Addendum No. 1

THE NATIONAL WORLD WAR II MUSEUM
FLOYD EDUCATION & COLLECTIONS PAVILION
1060 MAGAZINE STREET
NEW ORLEANS, LA 70130
MBA Project No. 12274

PROJECT NO. 12274	SHEET NO. P-101B
----------------------	---------------------

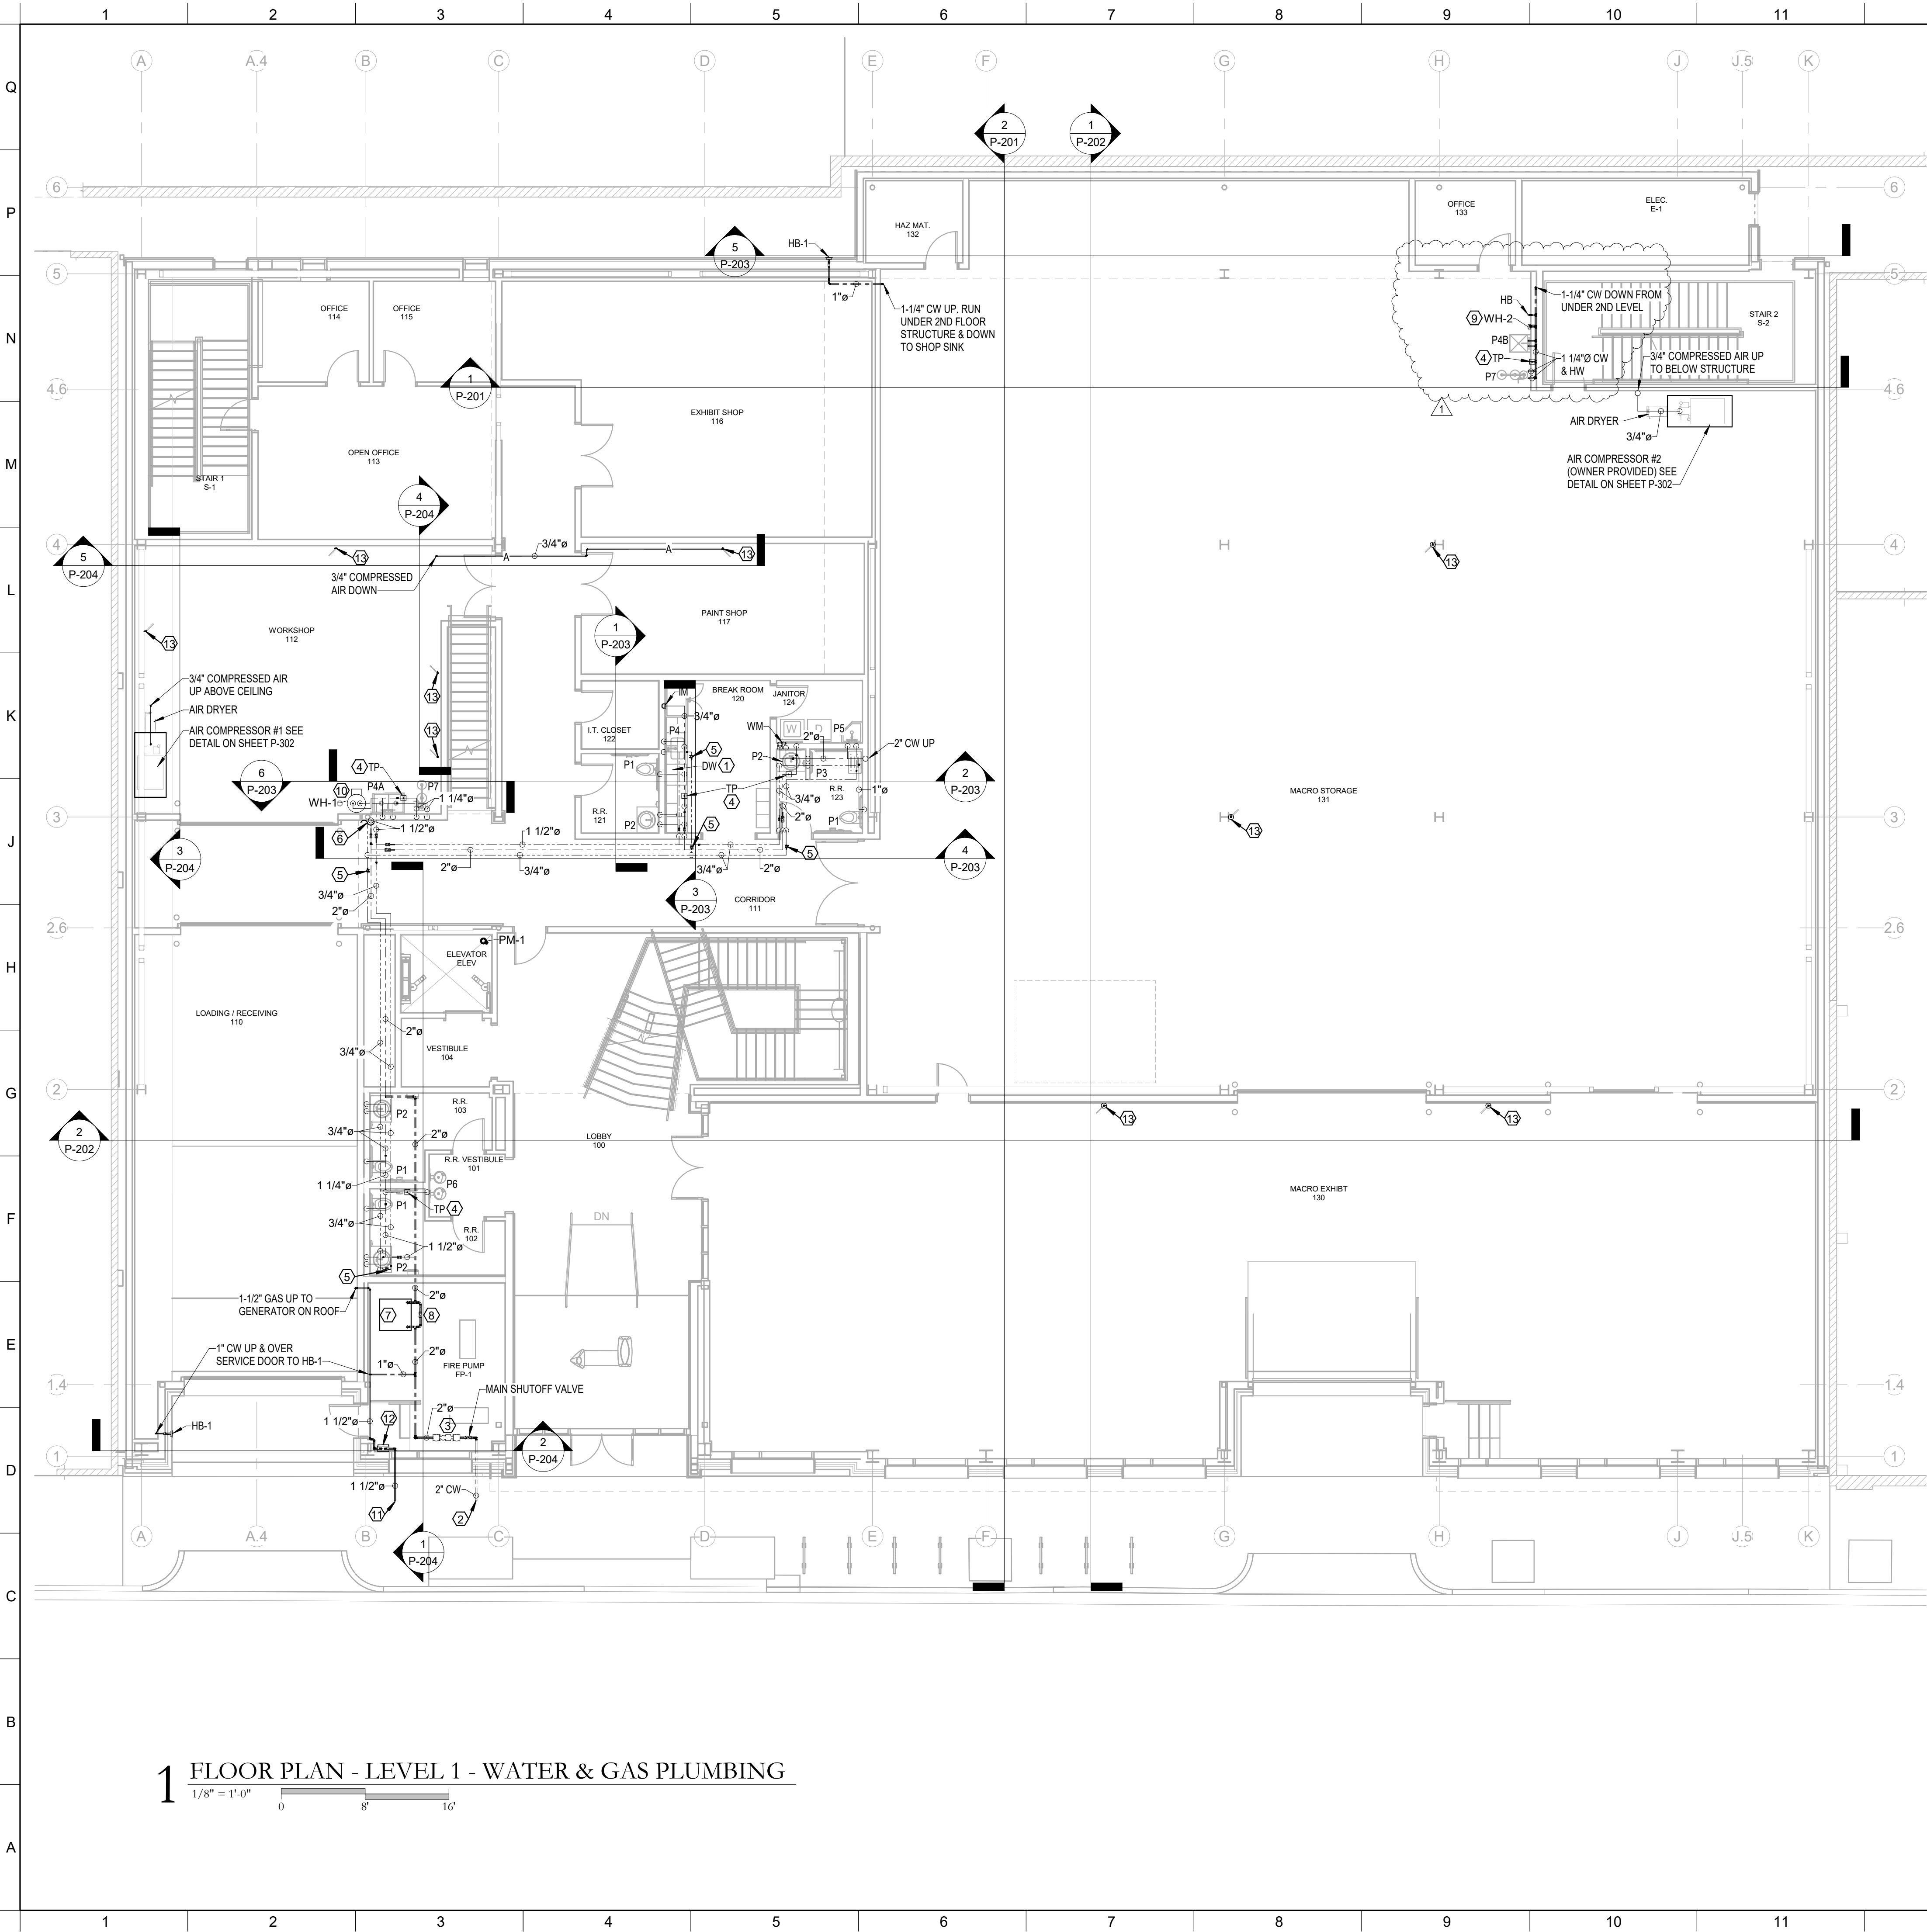
Item No. 5 - Drawing Sheet P-101B:

- A. Response to a RFI received: As indicated on the drawing, the air compressor #2 is Owner furnished and #1 is by the Contractor. The air compressor specified in specification section 15400-8 is for the “#1” air compressor.
